Subject: **Response to NRC Request for Additional Information Letter No. 206 Related to NEDO-33411, "Risk Significance of Structures, Systems, and Components for the Design Phase of the ESBWR," Revision 0 – RAI Numbers 17.4-18 through 17.4-47**

**Response to NRC Request for Additional Information Letter  
No. 206 Related to NEDO-33411, "Risk Significance of  
Structures, Systems, and Components for the Design Phase  
of the ESBWR," Revision 0**

**RAI Numbers 17.4-18 through 17.4-47**

Figure 1 – Process for Identifying Risk Significant SSCs

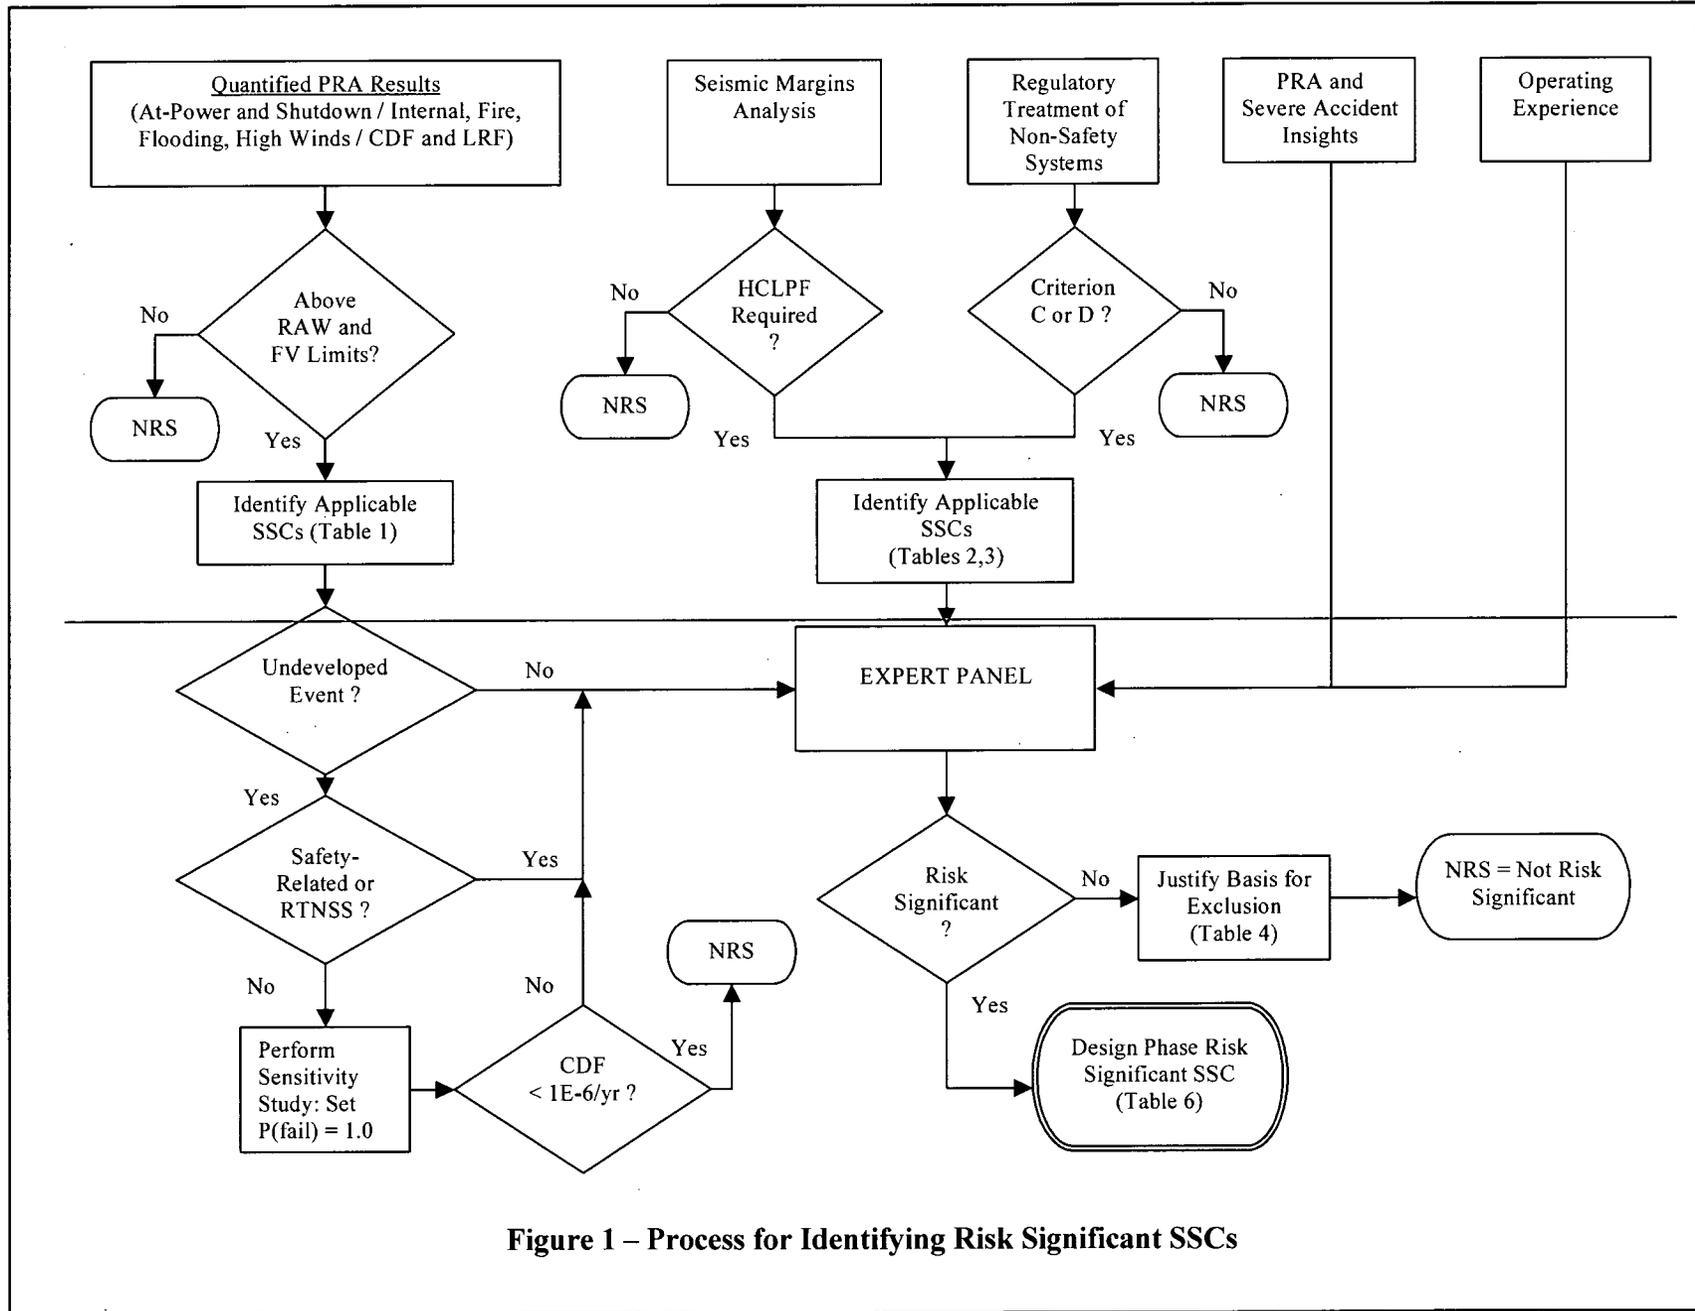
*Based on Section 2.6 and Figure 1 of NEDO-33411, Revision 0, the expert panel did not review the categorization of SSCs determined to be not risk-significant (NRS) from quantified PRA results, seismic margins analysis, and RTNSS. The expert panel plays an important role in reviewing the information that lead to these NRS determinations (e.g., assure the basis used in the categorization is technically adequate, review defense-in-depth implications, review safety margin implications, for additional information see Sections 9.2.2 and 9.2.3 of technical guidance report NEI 00-04, Revision 0). This is particularly important for those safety-related SSCs determined to be NRS from these processes.*

*The staff requests that GEH incorporate into their risk significance methodology the use of an expert panel to review the categorization of SSCs that were determined to be not risk significant from quantified PRA results, seismic margins analysis, and RTNSS. NEDO-33411, Revision 0, should be revised, accordingly, to describe the role that the expert panel has in reviewing these NRS determinations (e.g., assure the basis used in the categorization is technically adequate, review defense-in-depth implications, review safety margin implications).*

The GEH process for determining risk significance does include a review of NRS components by the expert panel. The methodology described in Section 2.6 states "the expert panel uses their collective experience to evaluate information from the inputs described in Sections 2.1 through 2.5." The input from Section 2.1 is the PRA-generated list of risk-significant and NRS components. Figure 1 of NEDO-33411 will be revised to clarify this process in Revision 1.
